Re: References Requested by June 23, 1992, Memorandum
and Order

Millstone Nuclear Power Station, Unit No. 2
Proposed Revision to Technical Specifications
Spent Fuel Pool Reactivity

Millstone Nuclear Power Station, Unit No. 2
Proposed Revision to Technical Specifications
Spent Fuel Pool Reactivity

FIG. 3.9-1 MINIMUM REQUIRED FUEL ASSEMBLY EXPOSURE AS A FUNCTION OF INITIAL ENRICHMENT TO PERMIT STORAGE IN REGION C

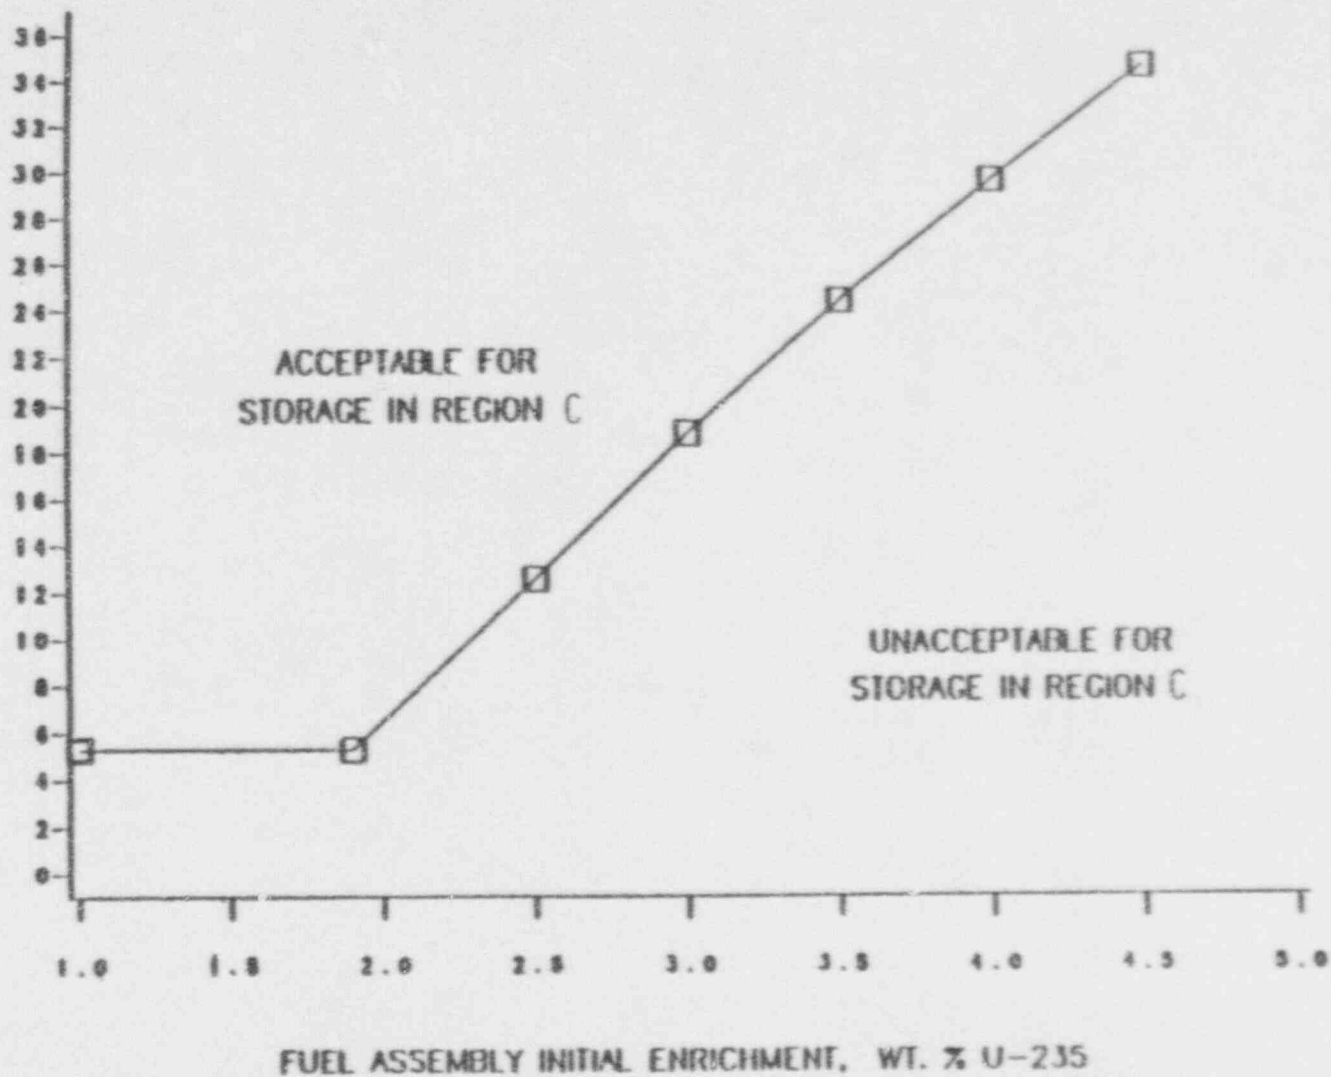
- 4) Figure 3.9-1 is being modified to change the references from Region II to Region C.
- 5) Figure 3.9-2 is being modified to delete the references from Regions I and II and add Regions A, B, and C.

FIGURE 3.9-3 MINIMUM REQUIRED FUEL ASSEMBLY EXPOSURE AS A FUNCTION OF INITIAL ENRICHMENT TO PERMIT STORAGE IN REGION C AS CONSOLIDATED FUEL

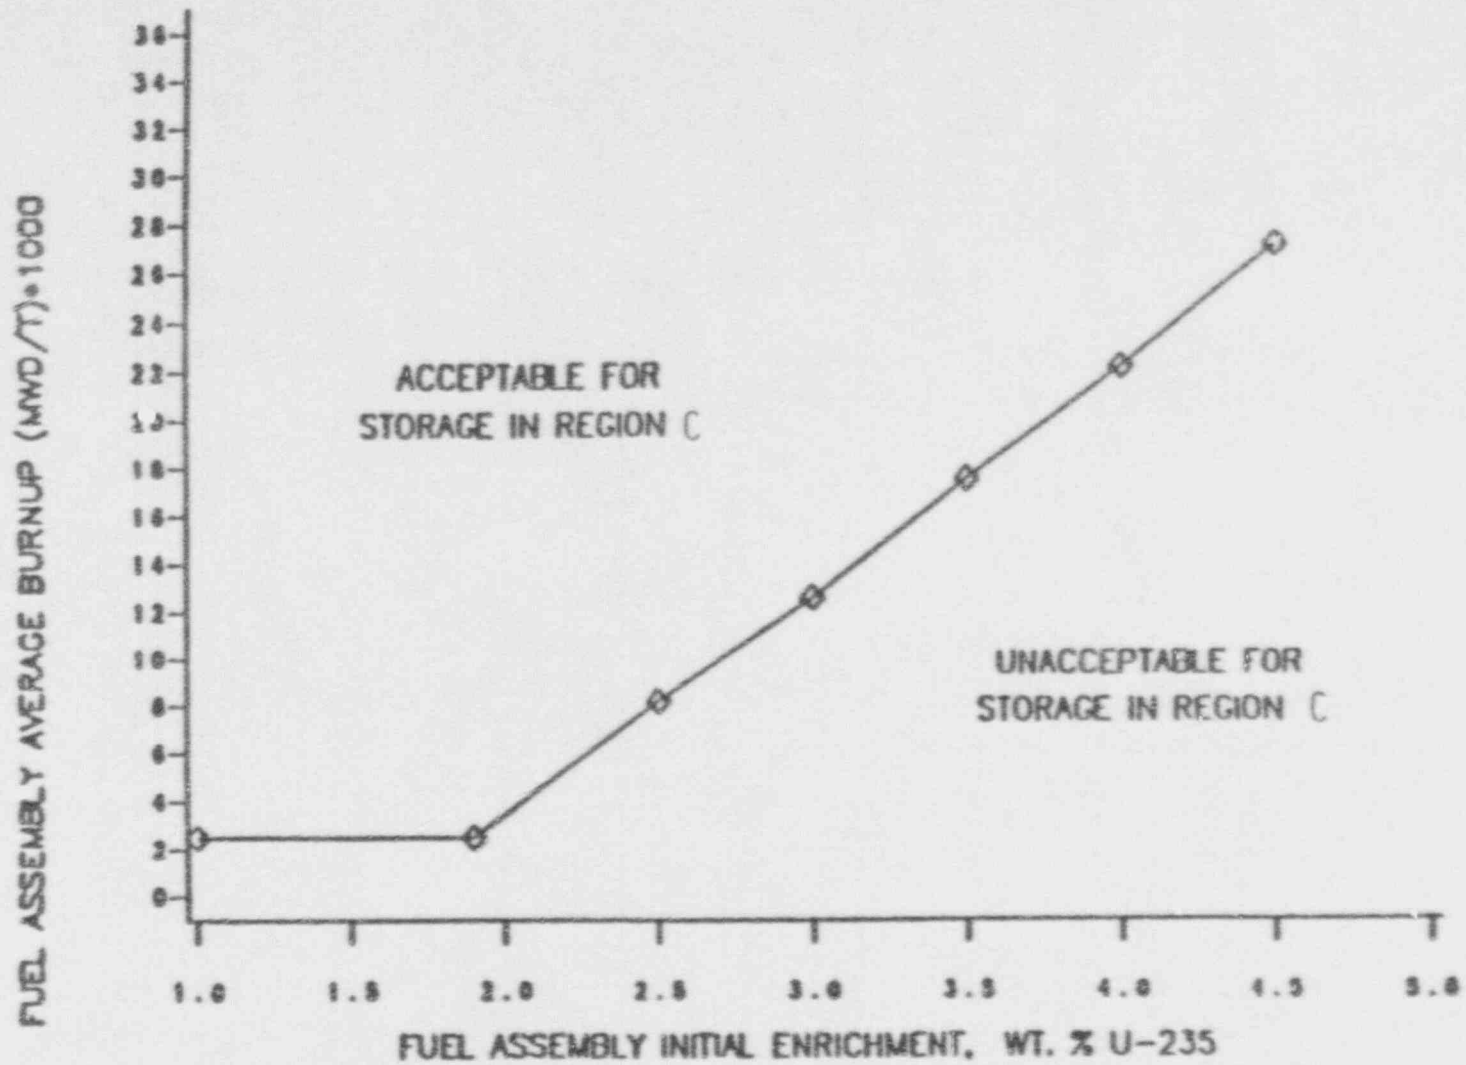
- 6) Figure 3.9-3 is being modified to change the references from Region II to Region C.
- 7) A new Figure (3.9-4) is being added to specify the allowable enrichment and burnup limits for fuel assemblies to be stored in Region A.

FIG. 3.9-4 MINIMUM REQUIRED FUEL ASSEMBLY EXPOSURE AS A FUNCTION OF INITIAL ENRICHMENT TO PERMIT STORAGE IN REGION A

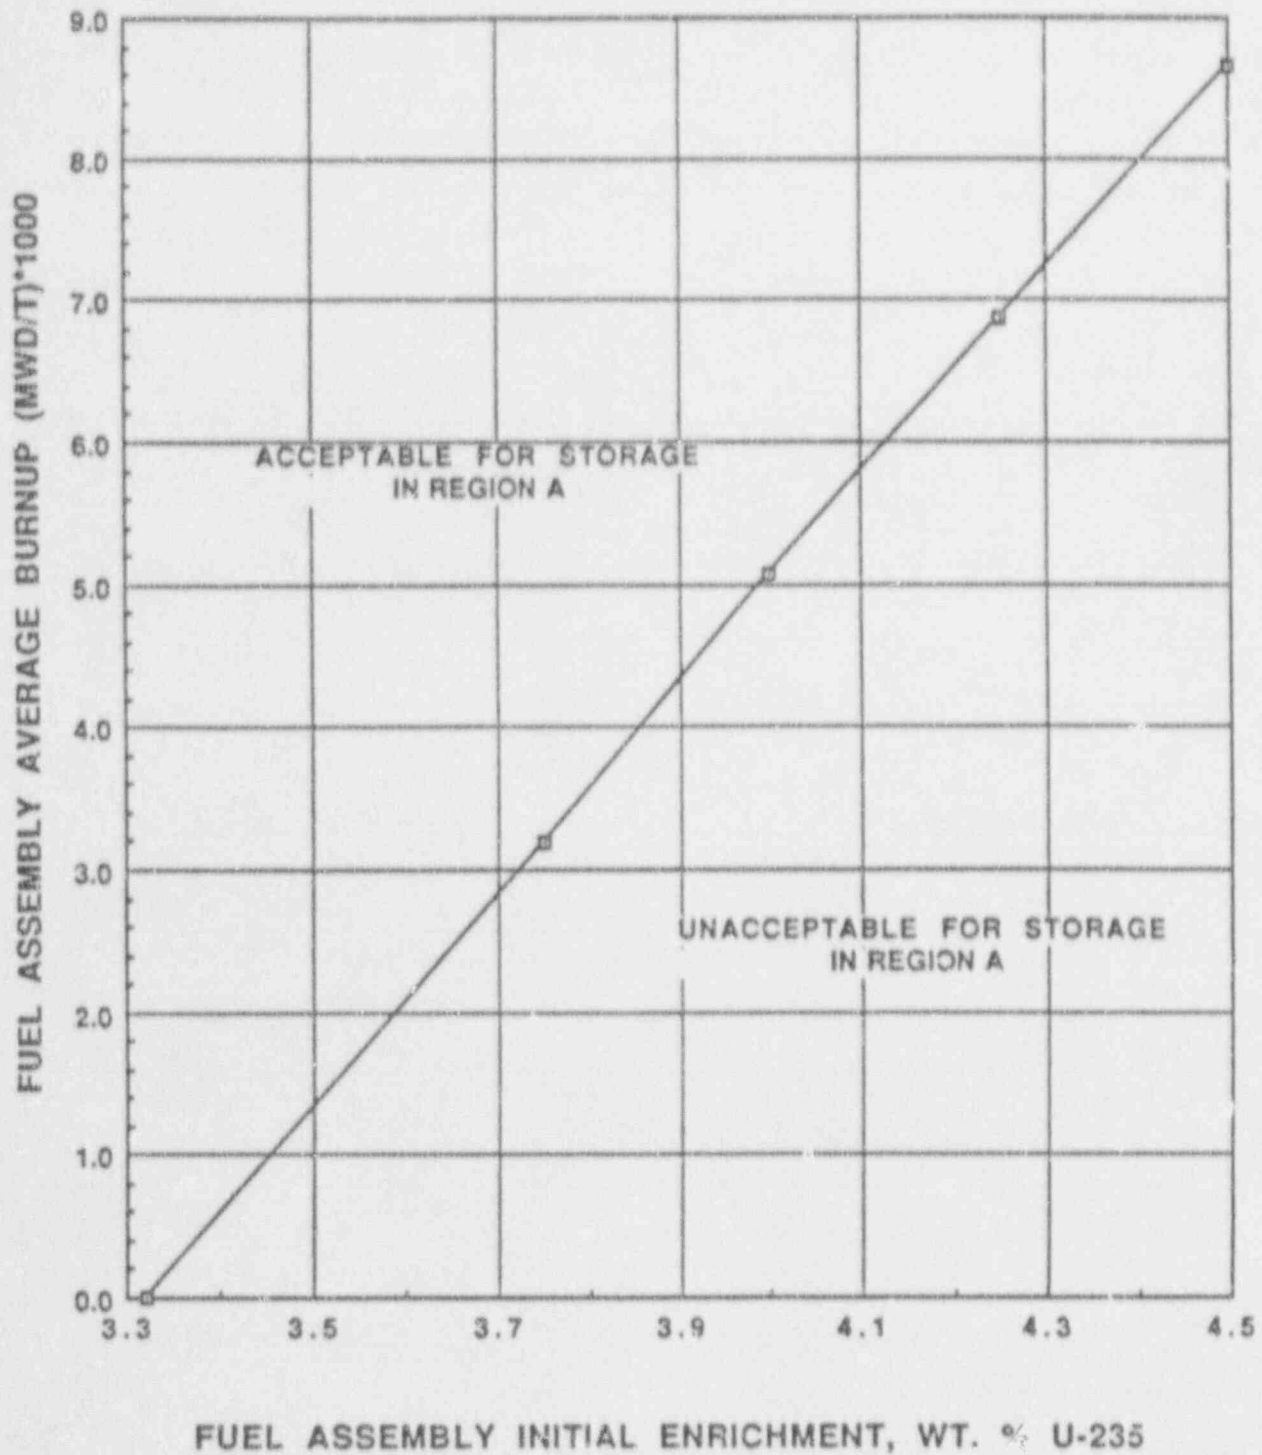
- 3) Specification 3.9.18 is being modified to change the wording in the surveillance requirements from Region II to Region C, and adds a surveillance requirement to ensure that fuel assemblies to be placed in Region A are within the enrichment and burnup limits of a new Figure (3.9-4).
